Overview: The initial production release of the FTI-TLK1 harness has an issue where in some vehicles the secondary power input to the CN1 connector will overload the associated vehicle circuit, causing a fuse to blow. This issue affects the initial release of harnesses and is already being addressed in production. A field correction procedure is detailed below in Figure 1.

FTI-TLK1 Type 3C1 - Vehicle Coverage & Preparation Notes

FTI-TLK1 Type 3C1 - Installation Notes & Wiring Diagram

Figure 1: Step by step adapter correction

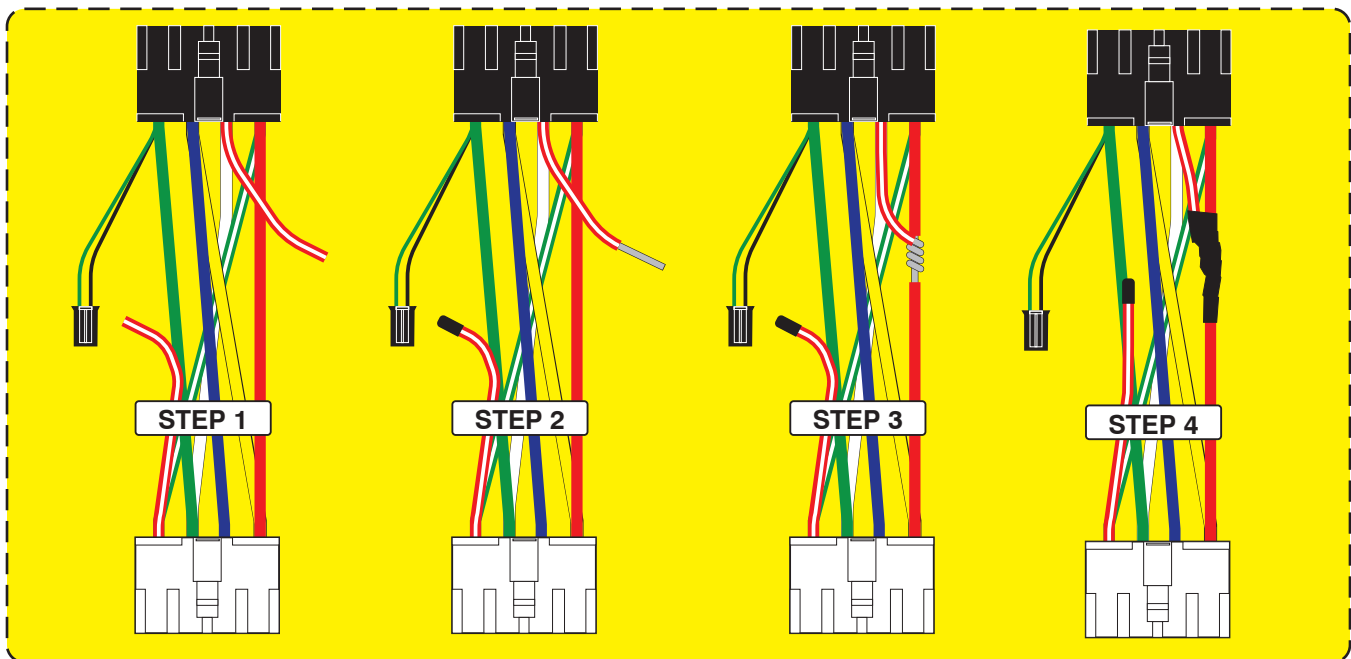
Issue: The secondary power circuit can overload some vehicle ignition switch circuits, causing a blown 5A/7.5A AM1 fuse, potentially disabling the vehicle and leaving the consumer stranded. Affected adapters are illustrated below in figure 2.

- 1.) Select the applicable CN1 adapter, isolate the RED/WHITE power wire, cut wire approximately 4" from the BLACK plug
- 2.) Insulate the wire still connected to the WHITE plug using heat shrink tubing, and strip the insulation on the other wire end
- 3.) Strip a portion of the insulation from the RED wire, attach the stripped RED/WHITE to the exposed RED wire, solder together
- 4.) Apply insulating tape to the soldered connection and secure the cut ends back to the bundle of wires created by the adapter
- 5.) Correction complete, you may safely proceed to finish your installation

Figure 2: Supplied CN1 Harness Adapters

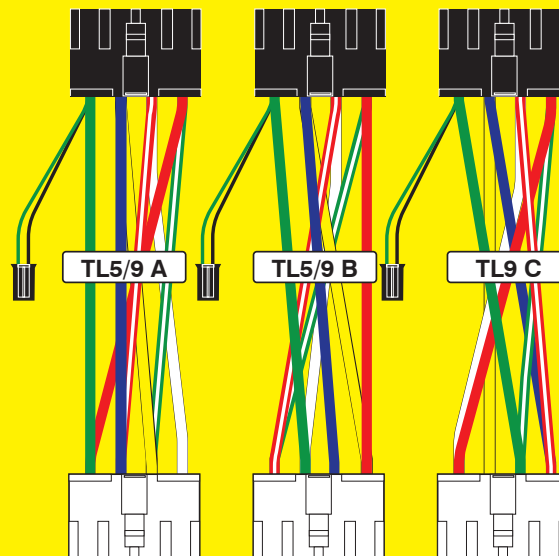
Incorrect power provisions with the potential to overload vehicle ignition supply circuit, resulting in blown AM1 fuse.
